2000-1 Addison Circle  
1998-1999 Hutt-Zollars Correspondence

Re: Addison Circle

PROJECT: ADDISON CIRCLE PHASE II - PUBLIC INFRASTRUCTURE  
 JOB NUMBER: 9809 / CHANGE ORDER NO. 1 (UTILITIES)  
 OWNER: TOWN OF ADDISON  
 CONTRACTOR: NORTH TEXAS CONTRACTING, INC.  
 DATE: 09/09/98

# Spectrum Drive

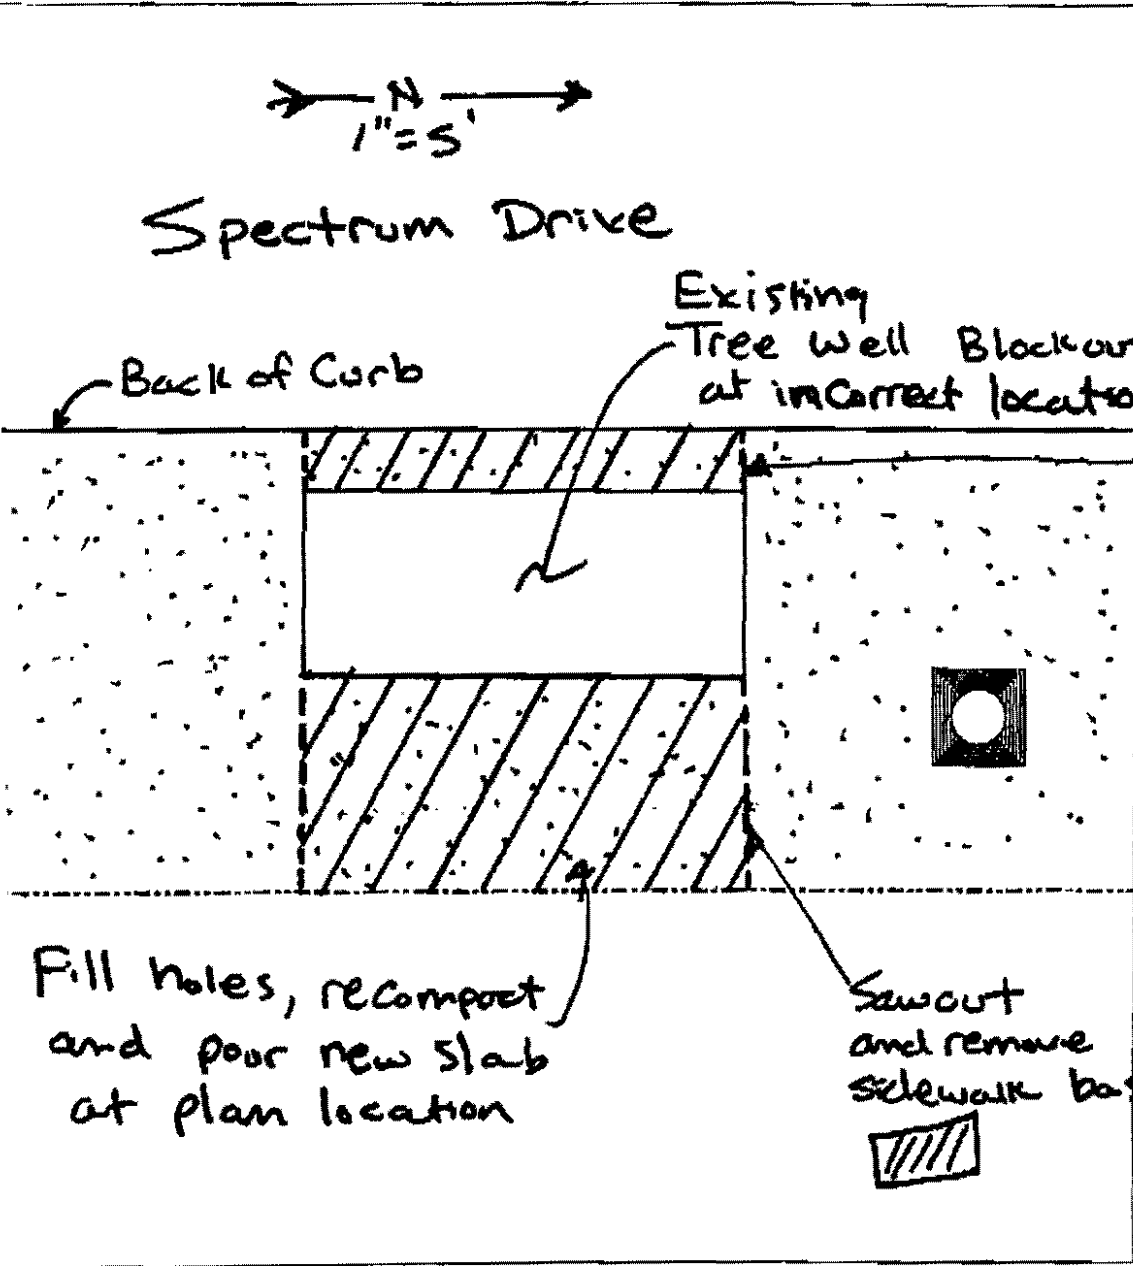
Enclosed please find a sketch indicating the removal and replacement limits for concrete base adjacent to the tree wells on the east side of Spectrum Drive north of Addison Circle. As you indicated, the tree well leaveouts are not at the correct location when measured from back of curb.

Existing Tree Well Blockouts at incorrect location

It is our recommendation that the concrete be sawcut and removed from back of curb to back of walk for the full length of the tree wells. The area should then be filled and compacted to meet density requirements. Then the concrete base should be repoured with the tree well leaveout at the correct location as indicated on the plans.

Fill holes, recompact and pour new slab at plan location

Sawcut and remove sidewalk base

Revision to Telephone Conduit plan

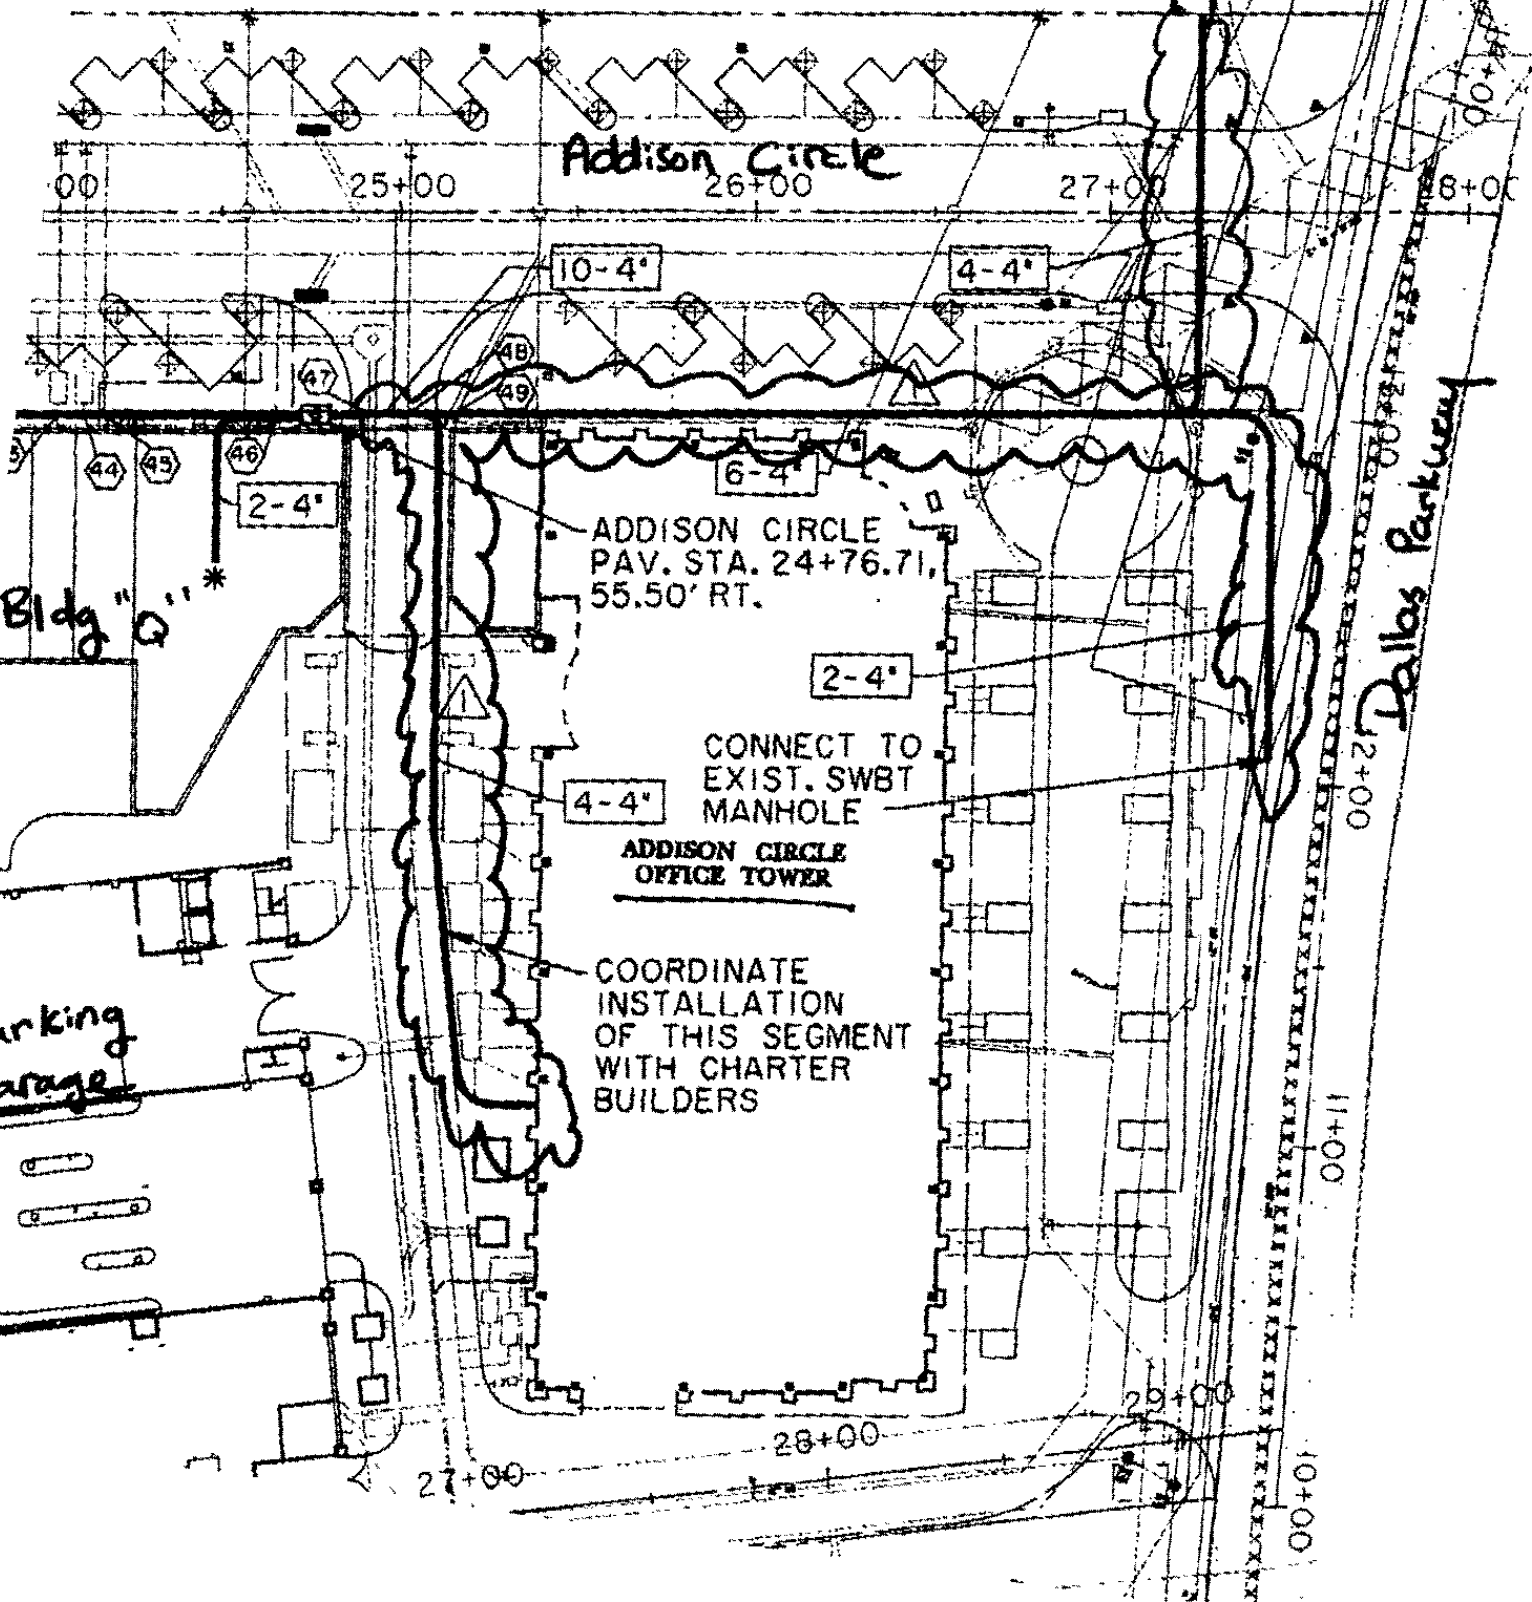
• Added conduit runs to exist SWBT manholes  
on Addison Drive and Dallas Parkway.

• Added conduits in private drive between office  
bdg and Garage; Deleted connection point  
on north face of office bldg.

Conduits have been added to the Sleaving Plan for this street crossing.  
(Previous fax sent to Post Construction)

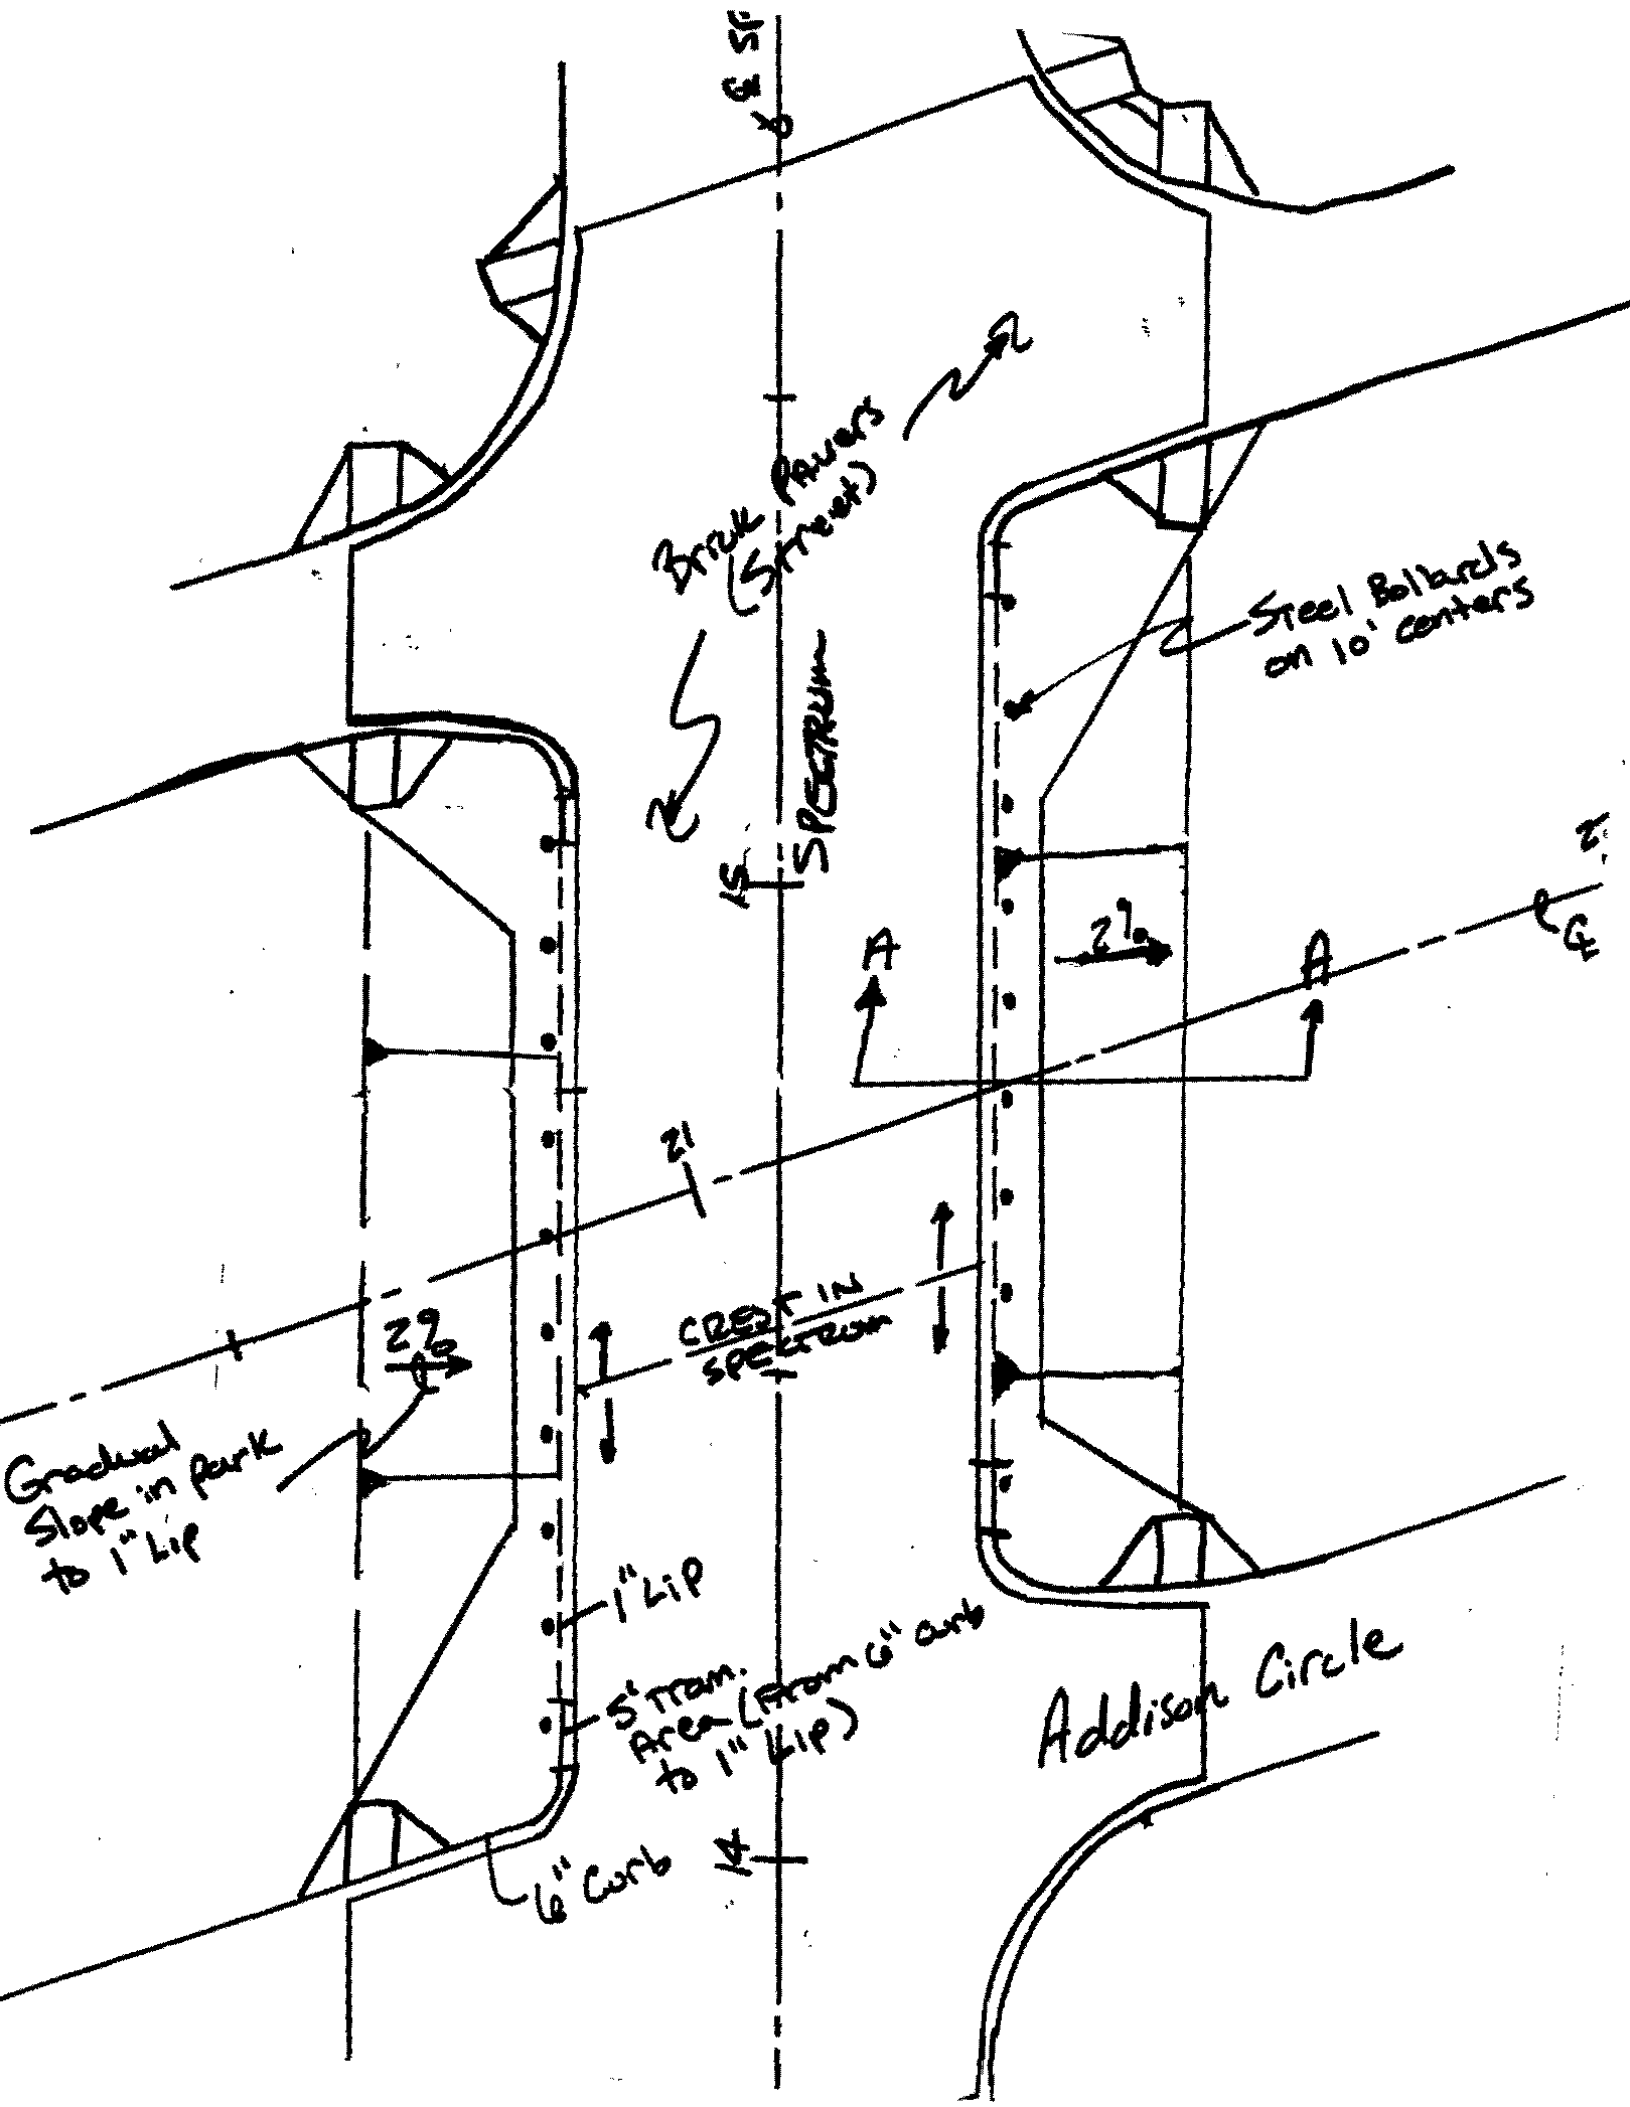
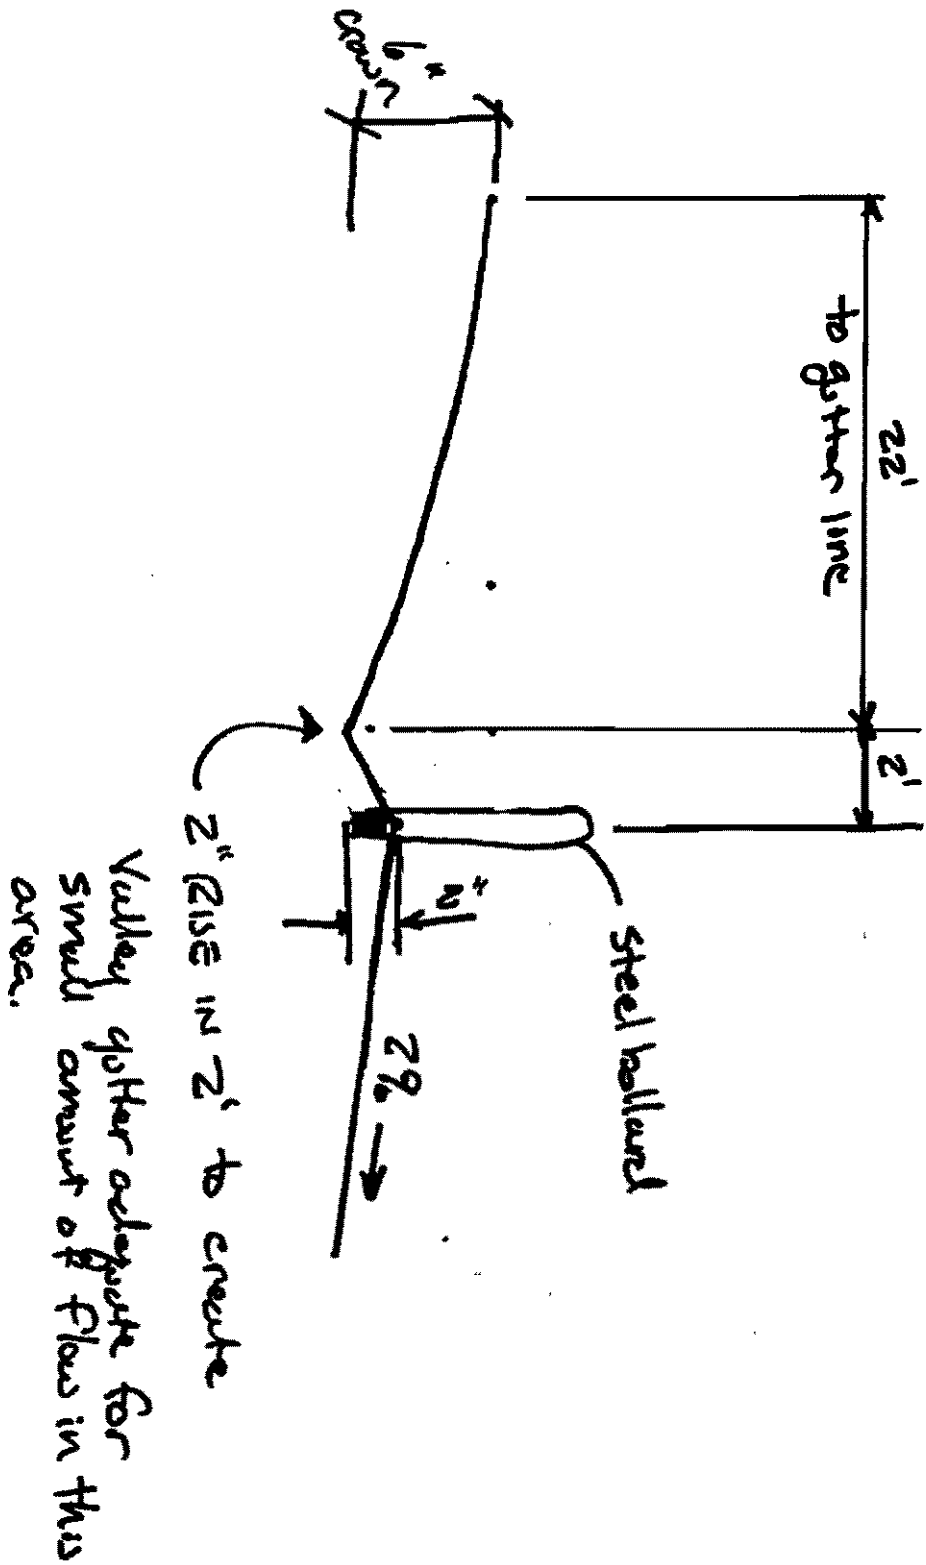
Enclosed please find a schematic drawing illustrating the proposed revision to the current design for the Spectrum Drive esplanade area. It has been the intent throughout the planning stages to have this section of pavement at the same, or at least appear to be at the same, level as the park to create a plaza effect. The city had many concerns about raising the pavement to the level of the park and a resolution was not reached prior to the job going out for bid. As a result the current design calls for a standard curb and gutter section.

We propose to revise the current design as follows:

- Transition from a 6" curb to a small valley gutter section which will slope 2" vertically in 2 horizontal feet from the gutter line on Spectrum Drive. This valley gutter section will occur between the curb returns at the Spectrum Drive and Addison Circle intersections.
- Slope the park at 2% to the valley gutter on the west side of Spectrum and at 2% away from the valley gutter on the east side of Spectrum.
- Add steel bollards on 10' centers 2' back from the gutter line of Spectrum Drive.

This will help to create a plaza effect without changing the profile grade of the roadway and will allow Spectrum Drive to function properly using stop sign control or signals if traffic warrants a signalized intersection in the future. The entire esplanade area will be brick pavement as currently shown on the design plans.
